**PUBLIC SCHOOL DEVELOPMENT  
STANDARD ADVISORY  
COMMITTEE<sup>1</sup>**

**RAINIER BEACH HIGH SCHOOL  
DESIGN DEPARTURE  
RECOMMENDATIONS**

**Project #3037700-SD**

**March 28, 2022**

**Exhibit 2 Proposed Height**

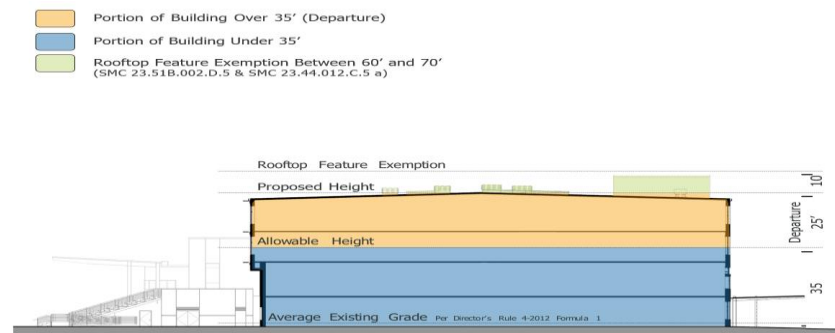
DON received one comment on this departure. The comment was critical of the increased height and contended it would be out of proportion to the surrounding neighborhood.

Altering the color scheme of the façade would help the building blend into the landscaping and surrounding neighborhood and visually reduce the bulk and scale of school's appearance.

**Recommendation 1 – That the departure to allow greater than allowed building height be GRANTED as requested by SPS with the following conditions:**

- 1) **SPS reconsider the façade to include warmer tones that blend into the landscaping and surrounding neighborhood to create an appearance of camouflaging the building.**

### Exhibit 3 Proposed Bus loading/unloading

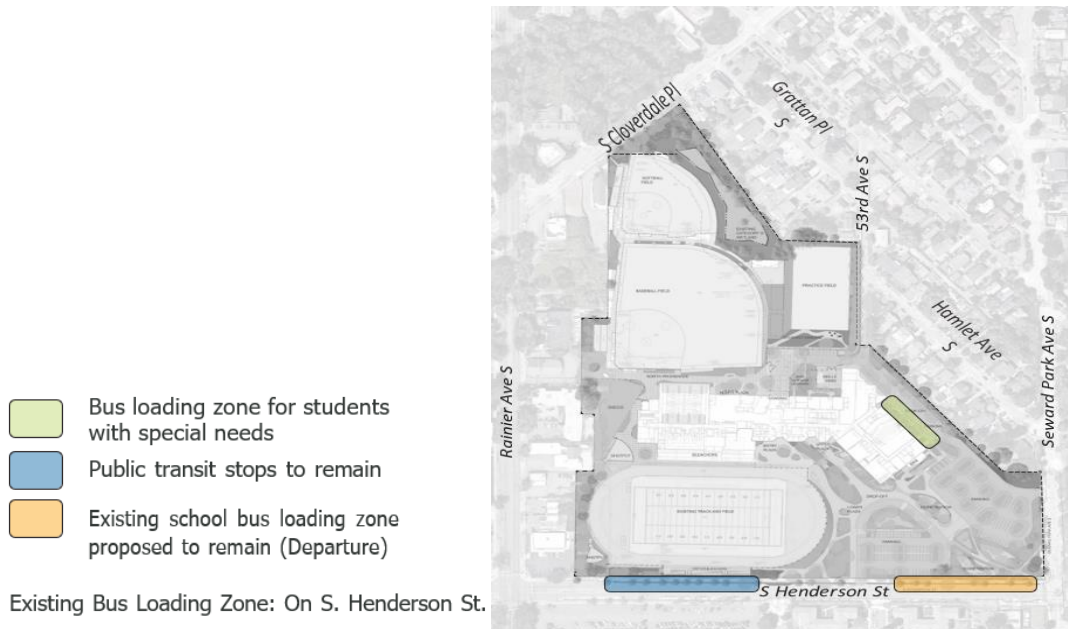
- 4) **Impacts on traffic, noise, circulation, and parking in the area** was considered and DON did have concerns about bus loading and unloading having an impact on traffic, circulation and parking the neighborhood.

DON received no comments regarding the bus loading and unloading departure request. SPS' request is to maintain the existing on-street bus loading area on S. Henderson Street.

**Recommendation 2 – That the departure to allow existing on-street bus loading on S. Henderson Street be GRANTED as requested by SPS with the following conditions:**

- 1) A robust School Transportation Plan (STP):** Prior to the school opening, SPS and the school principal should establish a STP to educate parents and students about the preferred access and circulation model. The STP should encourage supervised walking (such as walking school buses), carpooling, and school bus ridership for those eligible. The plan should define clear procedures and travel routes and preferred load/unload locations.

- 2) Engage Seattle School Safety Committee:** SPS should engage with the Seattle School Safety Committee (led by SDOT) to review walk routes and determine if any changes should be made to crosswalk locations, signage, pavement markings, school zone speed limits or crossing guard locations.

- 3) Develop a Neighborhood Communication Plan for School Events:** SPS and school administration should develop a neighborhood communication plan to inform nearby neighbors of events each year. The plan should be updated annually (or as events are scheduled) and should provide information about the dates, times, and rough magnitude of attendance to be posted at the school website. The communication would be intended to allow neighbors to plan for the occasional increase in on-street parking demand that would occur with large events.

**Exhibit 4 Proposed Message Board Sign**

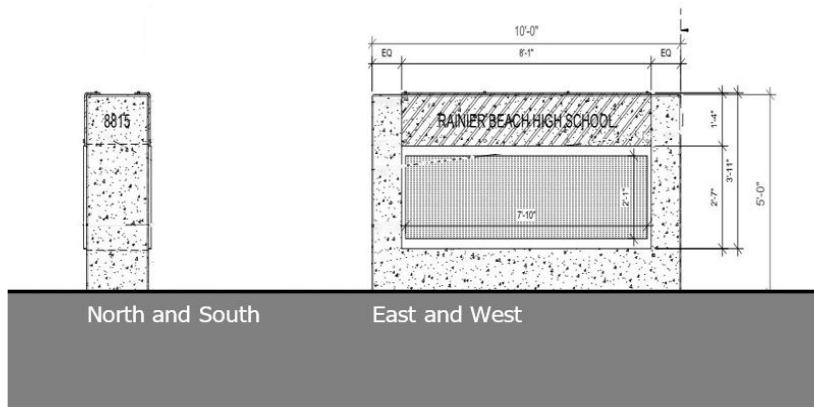
DON received one comment that was critical of this departure due to the flashing sign message sign that could present a visual distraction to pedestrians and drivers.

**Recommendation 3 – That the departure to replace the existing sign and allow a changing image electronic sign be GRANTED as requested by SPS with the following conditions:**

- 1) **The sign should be lit only when school is in session, and not used on the weekends.**
- 2) **to the sign should turn on no earlier than 7 a.m., and turn off no later than 7 p.m., except for special school events such as family nights and school programs, during which it can stay operational until 9 p.m.**
- 3) **Sign illumination should be limited to one color with a dark background.**
- 4) **No flashing, scrolling, or moving images.**

**Exhibit 6 Proposed Structures (Retaining Wall in Setbacks)**

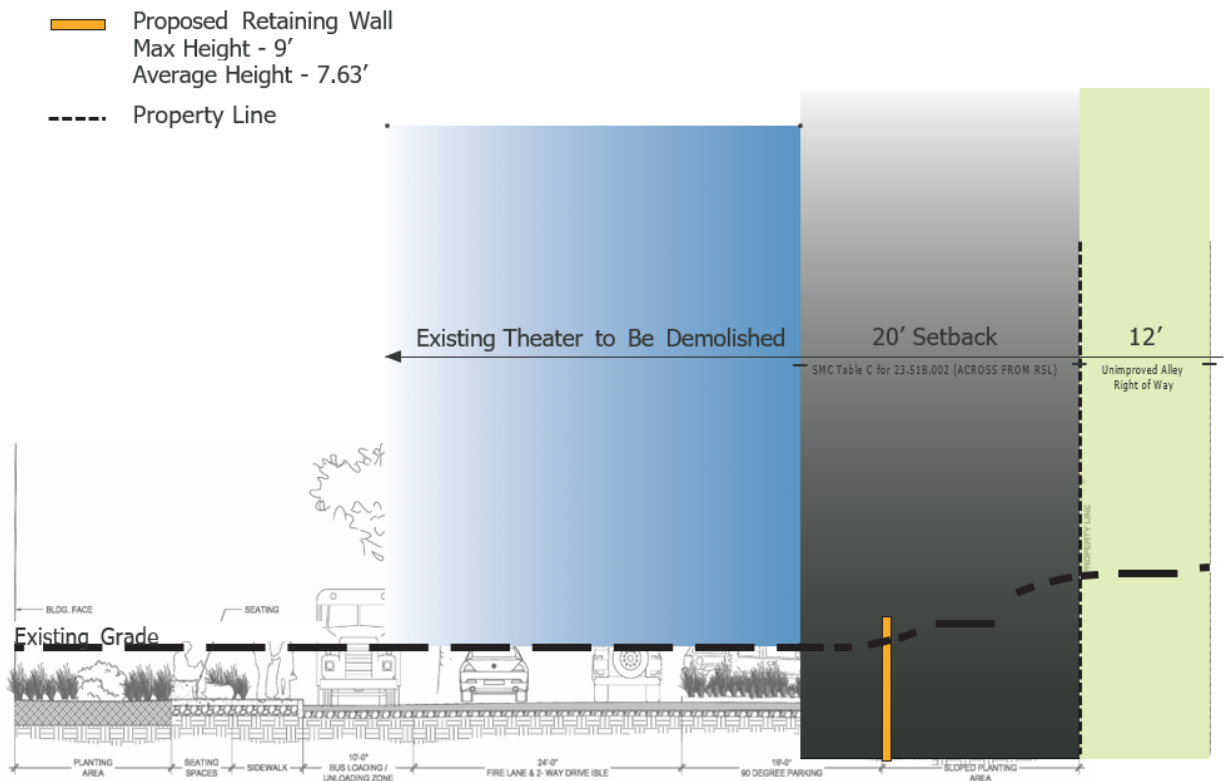
DON did not receive any comments regarding this requested departure.

**Recommendation 5 – That the departure to allow retaining walls to extend 3 feet above the 6-foot height maximum be GRANTED as requested by SPS.**

**Exhibit 7 Proposed Future and Temporary Portable Sites.**

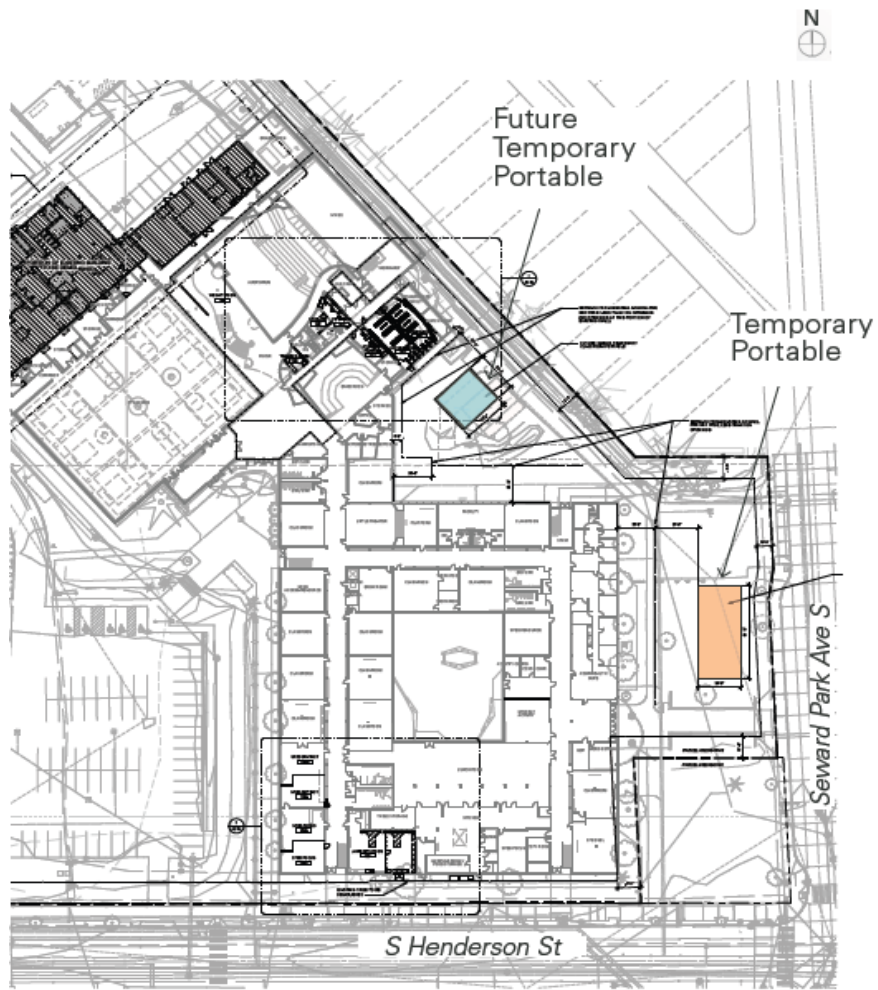
DON recommends allowing the proposed temporary portables for the existing school to help address anticipated space needs during construction with the following conditions:

- a. Informing the neighborhood about the installation and removal of the portables.

**Exhibit 8 Proposed Visitor Ticketing, Concessions & Restroom Building**

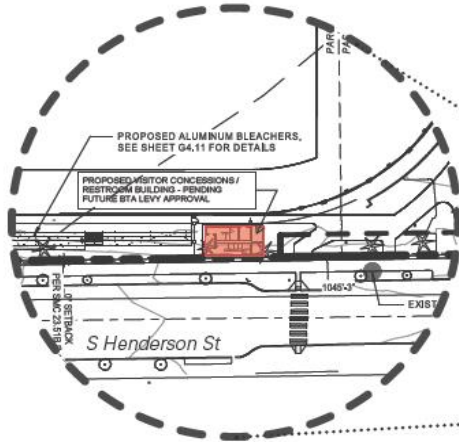
DON recommends allowing the proposed Visitor Ticketing, Concessions & Restroom building be located near the proposed visitor bleachers to provide a separate visitor amenity to help with crowd control during school events.
